Subject : Elevator drive

Affected : Sailplanes model "Club-Libelle 205" } F.R.G. Type Certif.
"Hornet" } No. 304
"Mosquito" } F.R.G. Type Certif.
"Glasflügel 304" } No. 318
- all variants, all serial numbers

205-33-9

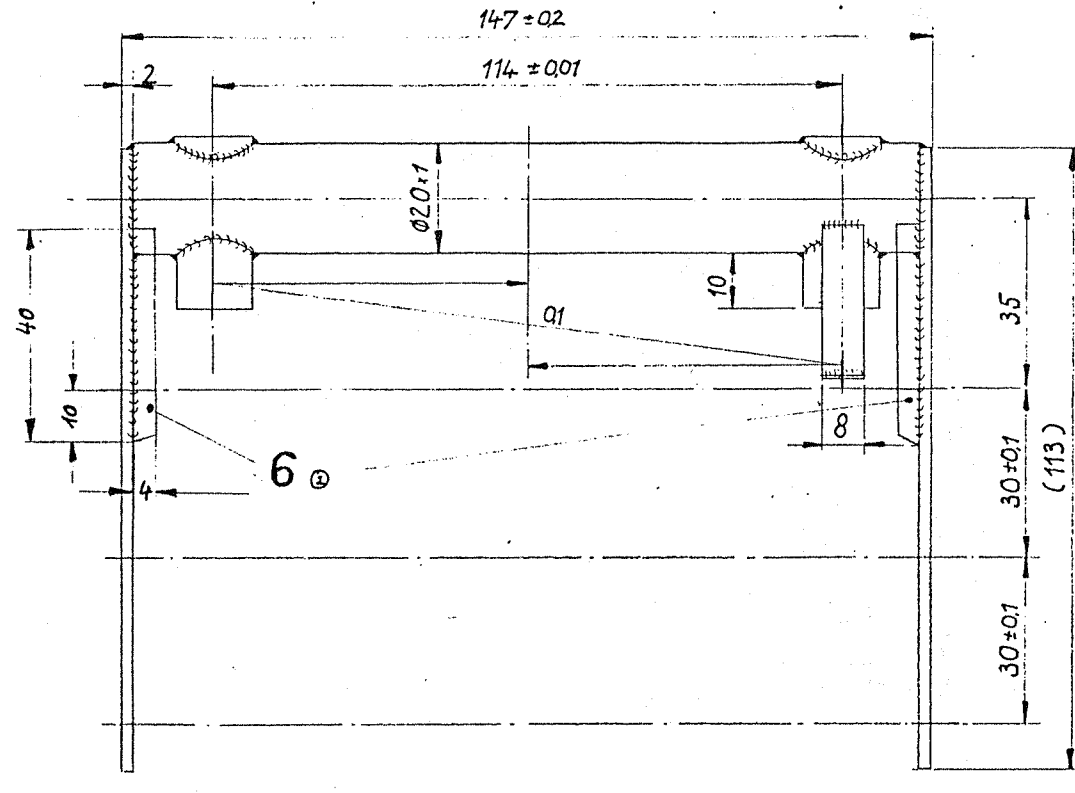
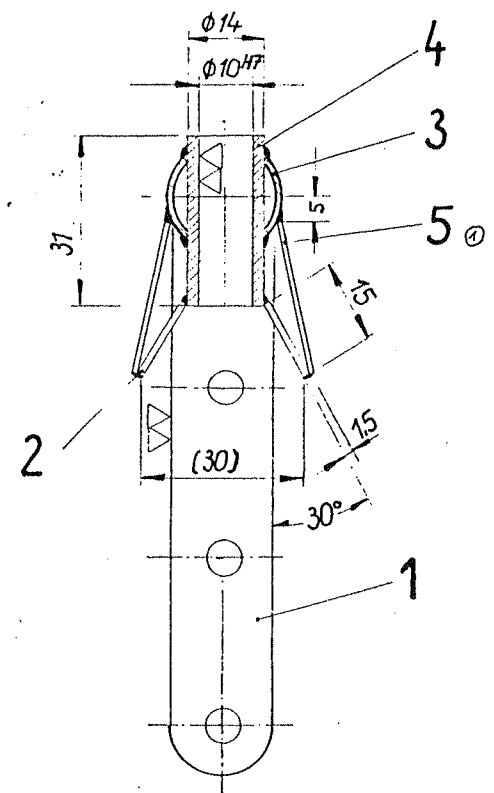
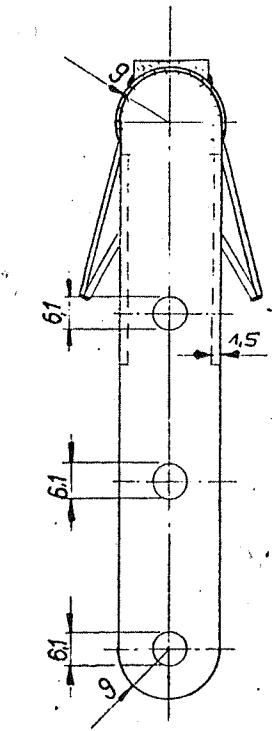
Reason : Difficulties in the control of the sailplane were encountered when an elevator drive bracket broke on one side in flight.

Actions : 1. On sailplanes having an earlier type elevator drive bracket (without reinforcements identified as part ⑥, modif. 2, on the drawing shown overleaf), a visual inspection for possible cracks in the bracket arms must be carried out. It must also be checked that the bracket arms are not twisted out of line.
2. On sailplanes having an earlier type elevator drive bracket (without reinforcements), the bracket must either be reinforced according to the drawing shown overleaf or be replaced by a reinforced bracket. When the tailplane is re-assembled, it must be made sure that the correct number of spacing washers are fitted between the bracket arms and the ball bearings (tag washers when removing the bracket).

Materials : The reinforced elevator drive bracket, manufactured according to drawing No. 205-33-9 (modification 2) or the additional metal strips with welding wire 1.7734.2 may be obtained from:
Hansjörg Streifeneder
Glasfaser-Flugzeug-Service GmbH
Hofener Weg
7431 Grabenstetten
Federal Republic of Germany

Note : Welding according to drawing No. 205-33-9 (modification 2) must be done by a licensed aircraft welder.
Accomplishment of action 1 must be done by a skilled person.
Accomplishment of action 2 must be entered in the sailplane's log by a licensed inspector.
